Inland Transport Committee

Working Party on Customs Questions affecting Transport

Approved amendments to the eTIR conceptual, functional and technical documentation - v.4.2a

Note by the secretariat

Figure 3
Guarantee status chart diagram

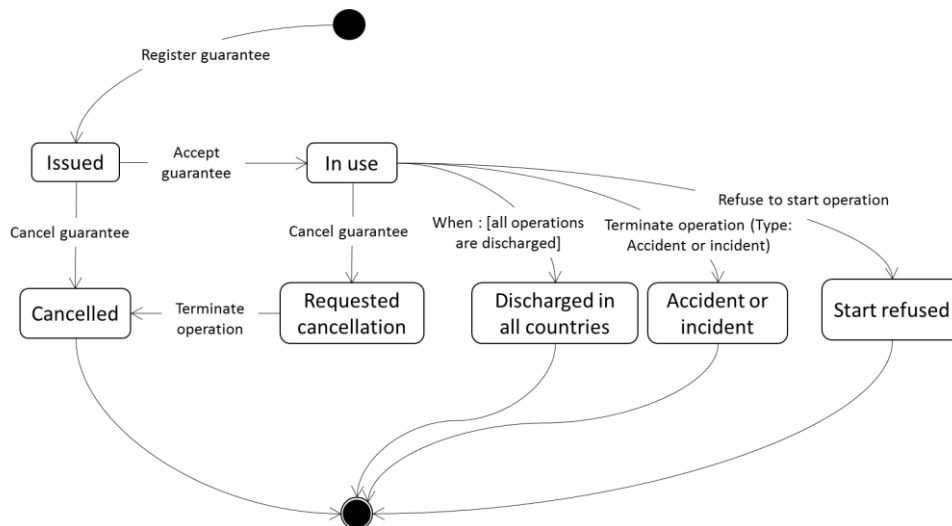
4. GE.1 took note that the status of the guarantee could not remain “in use” in case of accidents or incidents nor in the case of a refusal to start a TIR operation. Consequently, it requested the secretariat to introduce two new codes for the guarantee status and the corresponding rules for the eTIR international system in the next version of the eTIR specifications.

5. As a result, in the next revision of the eTIR specifications, the code list CL22 will be as follows:

6. Chapter “3.1.2 Guarantee state chart diagram” of the eTIR concepts document will list the two additional guarantee statuses.

7. Figure 3 in the same document will be amended as follows:

CL22	Guarantee status (eTIR)
001	Issued
002	In use
003	Cancelled
004	Requested cancellation
005	Discharged in all countries
006	Accident or incident
007	Start refused

Sequence of messages

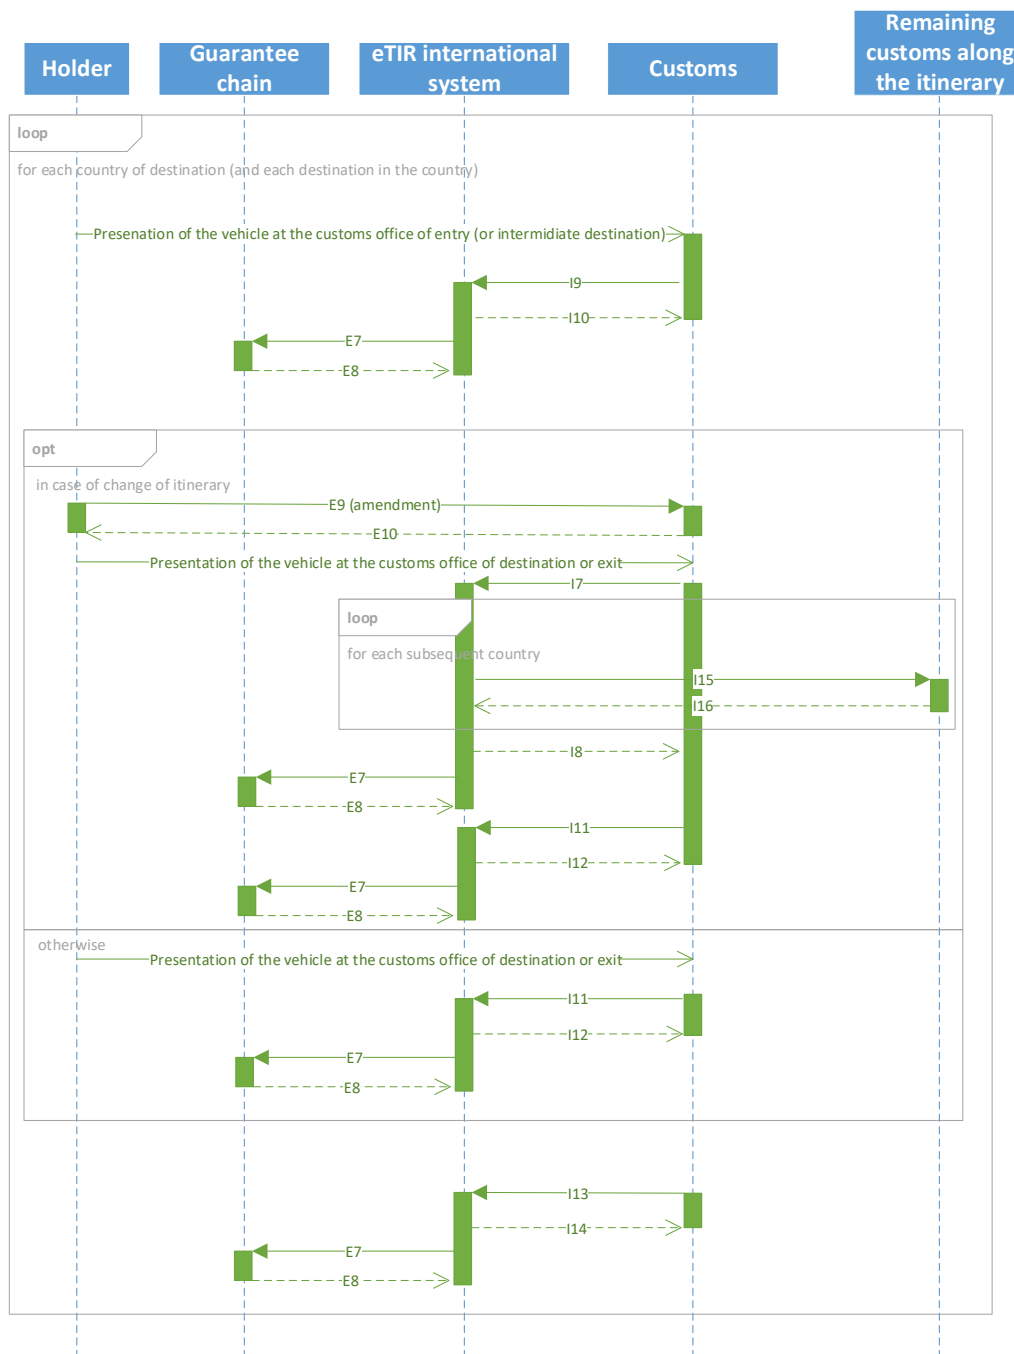
3. The sequence diagrams describing the standard sequences of eTIR messages for countries of departure, transit and destination (as contained in Annex I) will be included in the next revision of the eTIR functional specifications as a new Annex.

Figure 1.47: (English only)
Check customs offices UML diagram

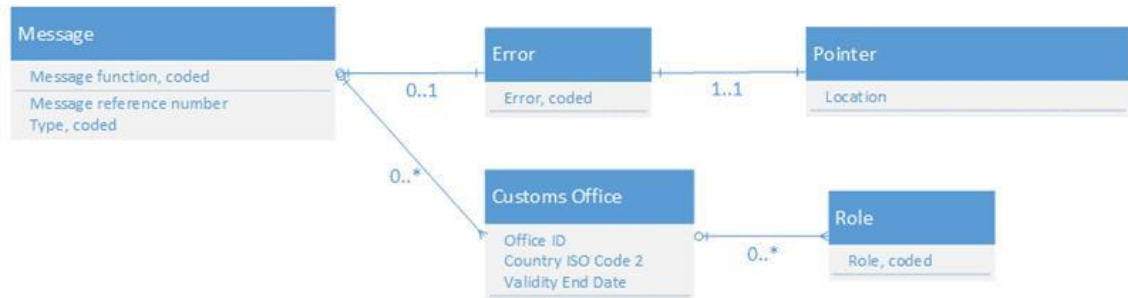
25. The I19/I20 messages contained in Annex V should be included in the next version of the eTIR specifications, together with other necessary changes in use cases, activity diagrams and sequence diagrams.
